**LANE PARKE**  
**Mountain Brook Village**

**PUD AMENDMENT APPLICATION**

# P-19-20

Request for approval of an amendment to the Planned Unit Development (PUD) for Lane Parke.

Figure 1. Drive-Through Locations

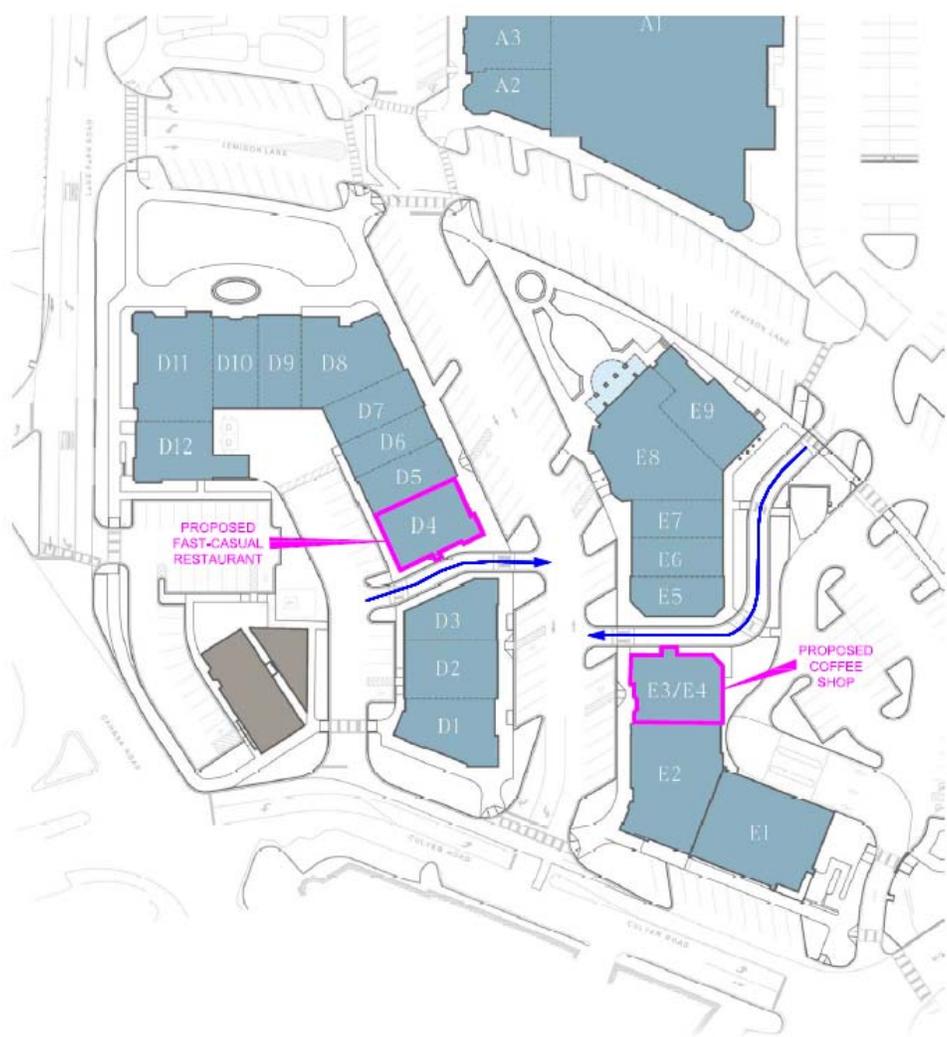
The proposed drive-thru lane that is to access a coffee shop (Block 10) has the capacity to store nine vehicles. At the bottom of Page 5 (Skipper Queue Study), based on a Skipper study of a Starbucks in Trussville, it is anticipated that the queue for the proposed coffee shop would exceed the nine-queue storage available for 6 minutes per day, as follows:

If the queue exceeds the nine car available queue storage, vehicles will interfere with the flow of traffic on Jemison Lane.

The proposed drive-thru lane that is to access a fast-casual restaurant (Block 8) has the capacity to store two vehicles. Charts on Pages 5 and 6 of the Skipper Queue Study indicate frequent excesses of the 2-car queue storage limit throughout the day (between 4-6 cars in the queue). At the bottom of Page 6, the study indicates that no queue is expected to impede traffic on Culver Road.

However, if the queue exceeds the two car available queue storage, vehicles will interfere with the use of on-site parking (behind the Ray & Poynor building) and it would seem

that there is at least some unknown risk a queue could impede traffic flow on Culver Road.

At its meeting of July 1, 2019, the planning commission recommended approval of the proposed drive-thru amendment (P-19-20), with a condition that the language be tightened up with regard to specific proposed tenant types and specific locations within Lane Parke. Language has been added to require a traffic/queue analysis and city council approval for each and every proposed drive-thru in the project; every time a new tenant drive-thru is proposed in future.
